**Final Environmental Impact
Statement on Modifications to
Monroe Harbor , Michigan**

FEBRUARY 1980

OFFICE OF THE CHIEF OF ENGINEERS
DEPARTMENT OF THE ARMY
WASHINGTON , D.C. 20314

FINAL ENVIRONMENTAL IMPACT STATEMENT
MODIFICATIONS TO MONROE HARBOR
MONROE COUNTY, MICHIGAN

Fig 1 Survey sheet of the Federal navigation channel, 1884.

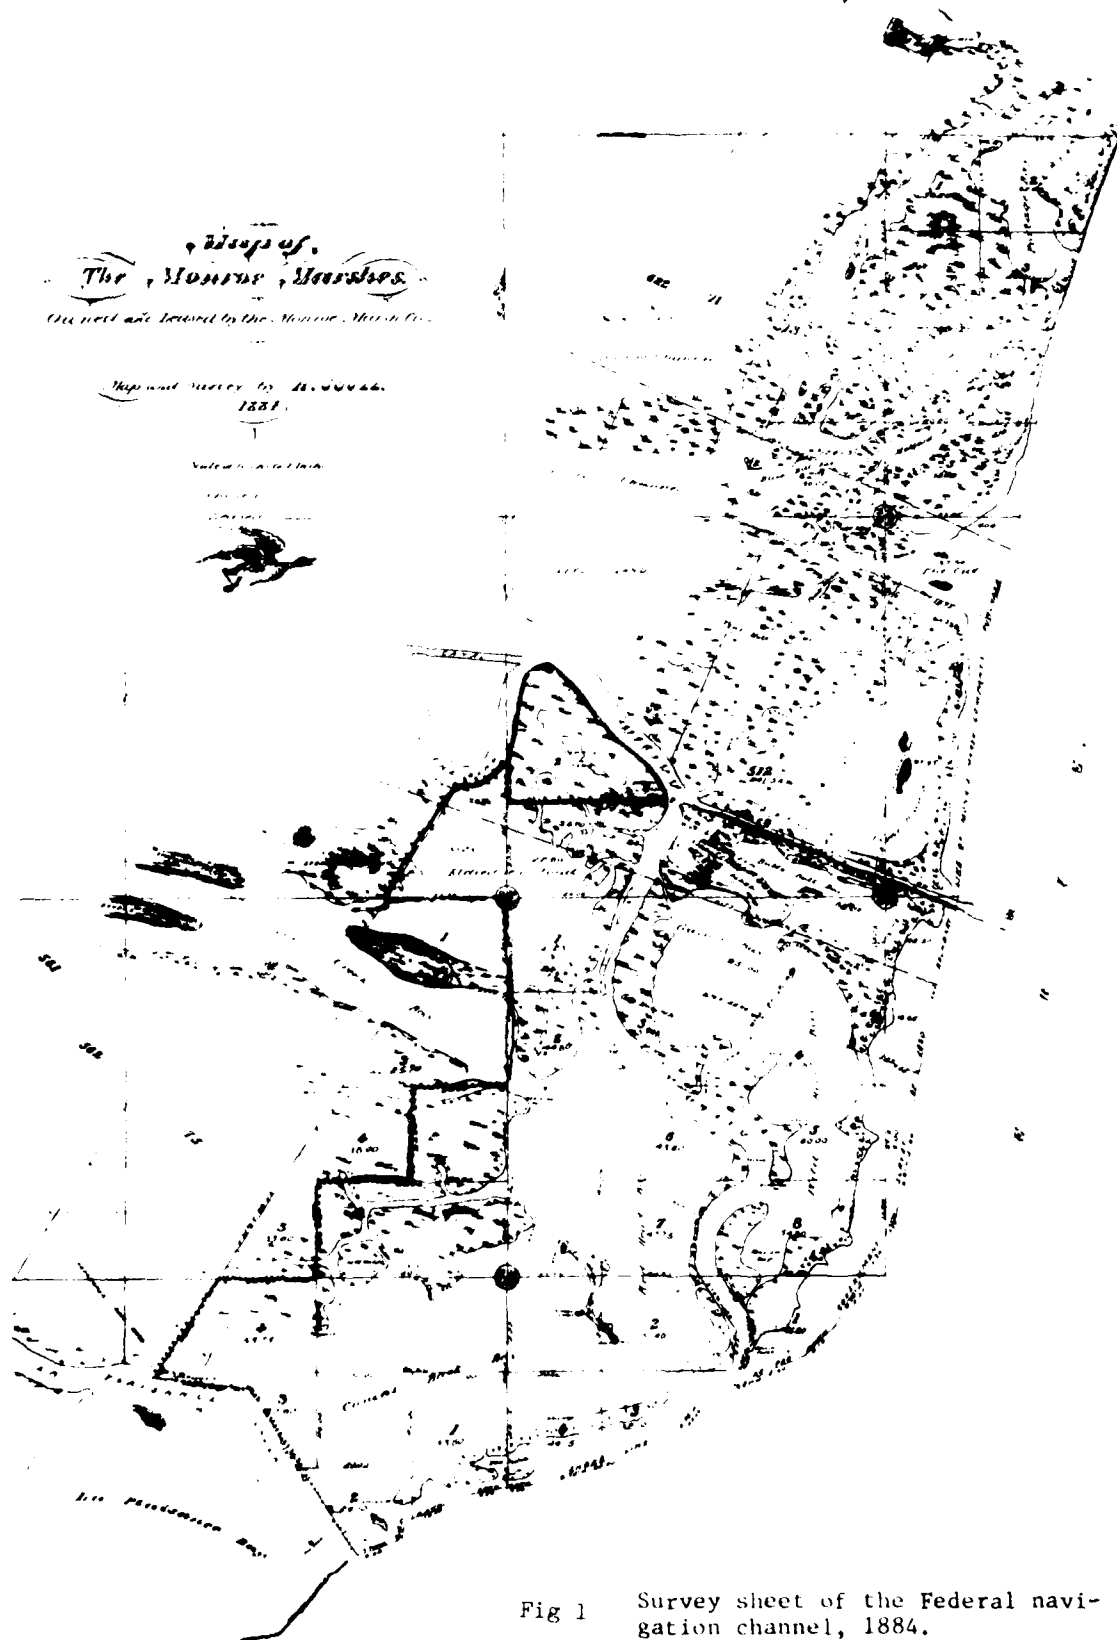
Response: The statement has been modified. However, re-creating a marsh in this area of former marshland should not prove difficult. Old maps (See Figure 1) and photos indicate that an extensive marsh system was formerly in the area. It was protected by a barrier beach. This beach has been eroded away, and now only two patches of sago pondweed are enduring under the present conditions. The CDF would artificially create the former barrier beach. Although natural revegetation of the marsh is expected, initial seeding may be desirable. Details of creating a viable marsh ecosystem would be accomplished in the general design memo study phase.
